***Royal Rehabilitation Centre Sydney
(MP 05_0001 MOD 2)***

600 – 640 Victoria Road, Ryde

***Modification of residential layout including
modifications to roads, open space and built
form layouts, building heights and density
within Stage 2.***

Secretary's
Environmental Assessment Report
Section 75W of the
Environmental Planning and Assessment Act 1979

Figure 19: Proposed Road Layout

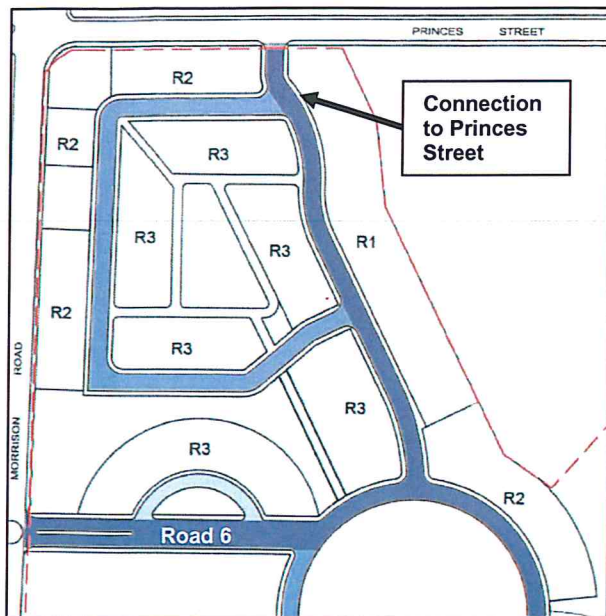
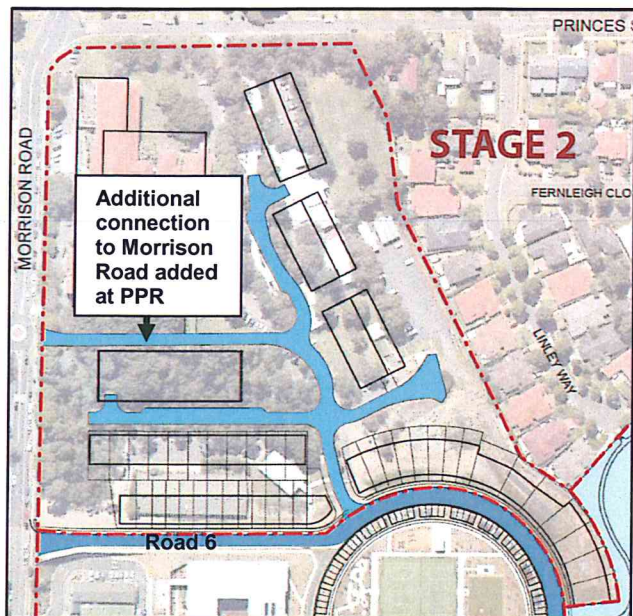
The Concept Plan approval provides for vehicular access points to Princes Street and Morrison Road (**Figure 18**). The proposal, as exhibited, sought to delete the through-site vehicular access to Princes Street without providing an alternative access point. As such, most traffic accessing and leaving the site would travel via Road 6 within the Royal Rehabilitation Centre into Morrison Road to the south of the site.

Concerns were raised by Council and public submissions from the Royal Rehabilitation Centre and other nearby residents that this would concentrate traffic in one location, and impact on safety and amenity, particularly to the Royal Rehabilitation Centre.

In response to these concerns, a new connection to Morrison Road is now proposed (refer **Figure 19**), enabling a through-flow of traffic and a more even distribution of traffic flows. The proponent advised that the deletion of the access point to Princes Street arose as a direct result of community consultation, as residents had expressed to the developer a desire to reduce traffic flowing onto Princes Street.

The Department considers that the additional site access point will allow for a reasonable distribution of traffic flows through and around the site and that traffic flows adjacent to the RRCS would not be materially different from traffic flows under the approved layout.

Figure 20: Approved Open Space & Pedestrian Paths

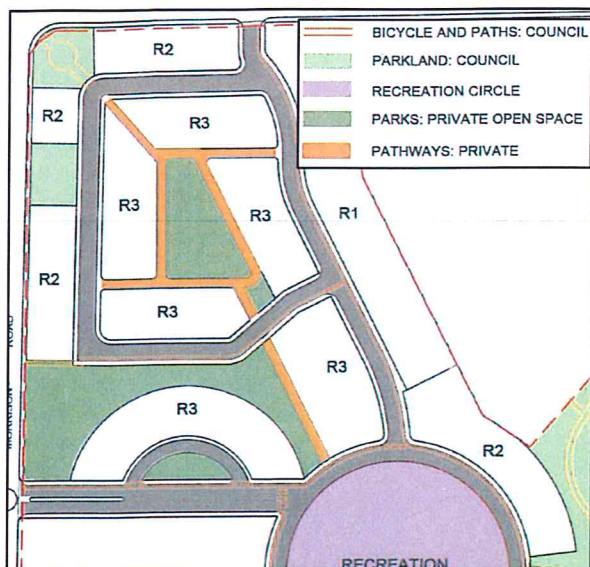
The modification request deletes the pedestrian access point from the corner of Morrison Road and Princes Streets as a result of the proposed new building layout and the steep topography of the site which would include numerous stairs to achieve a continuous pedestrian link.

Council requested more information and detail on pedestrian connectivity on the site.

Despite the deletion of the access point, the Department is satisfied that the proposal improves pedestrian connectivity with numerous additional public pathways through the site compared to the Concept Approval layout. A comparison of pedestrian accessways is provided in **Figures 20 and 21**. This illustrates that the proposal maximises pedestrian permeability though the site within the constraints of the topography and proposed layout of the site.

The Department notes that detailed design of the pedestrian pathways will be provided to Council within future development applications.

Figure 22: Proposed basement parking locations

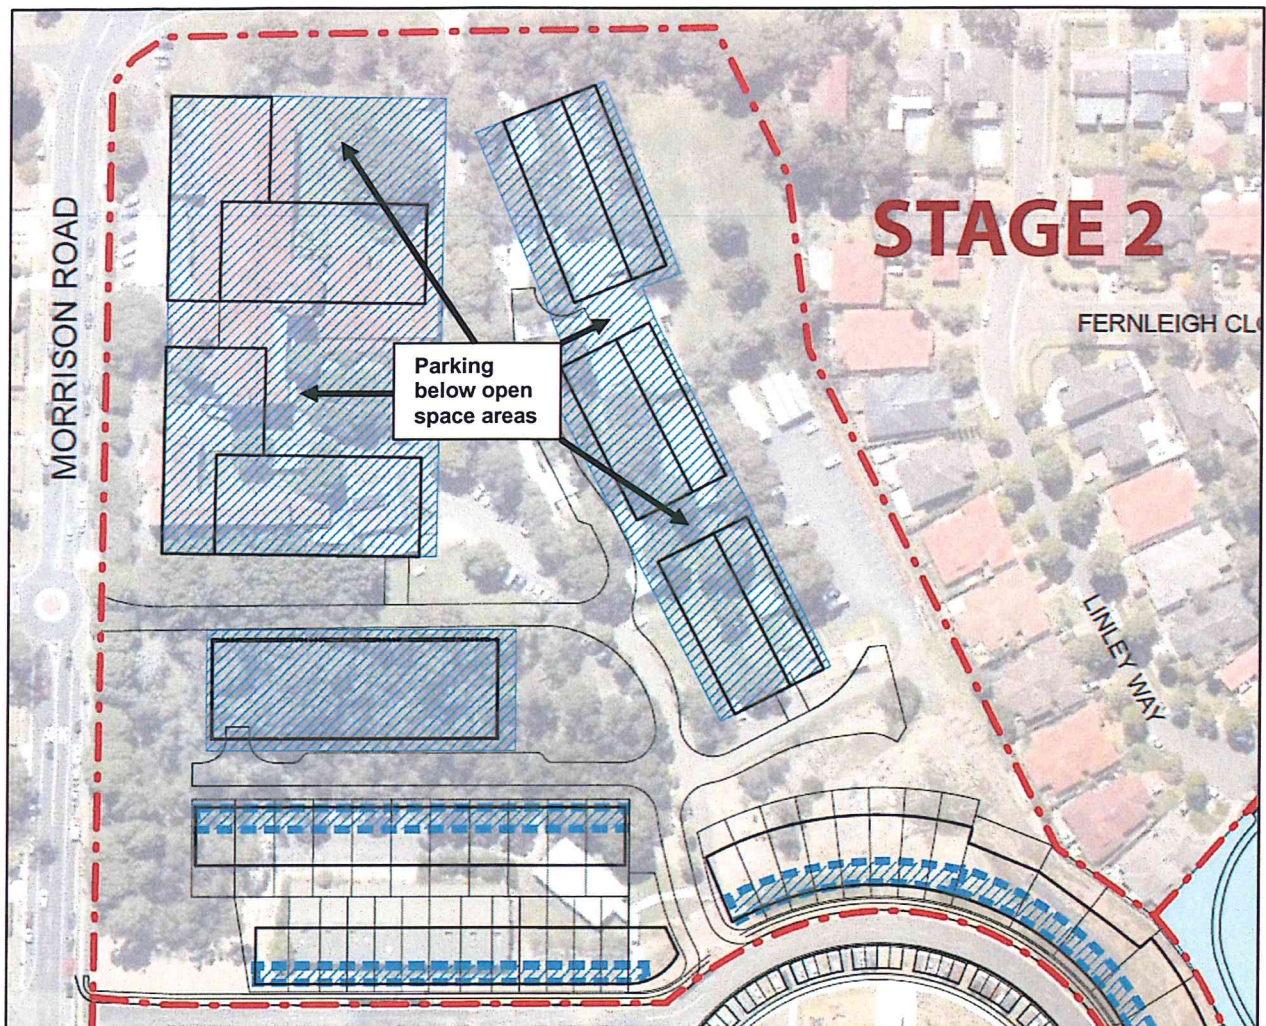
The open space also includes areas above basement parking as shown in **Figure 22**. While basements in the existing Concept Approval were generally limited to areas below the building envelopes, basement parking under open space areas is considered acceptable, providing future applications can provide appropriate drainage and soil depths to support a variety of landscaping including mature trees to a height of at least 10 metres. This is consistent with the approach taken in Stage 1 and already addressed in condition B16.
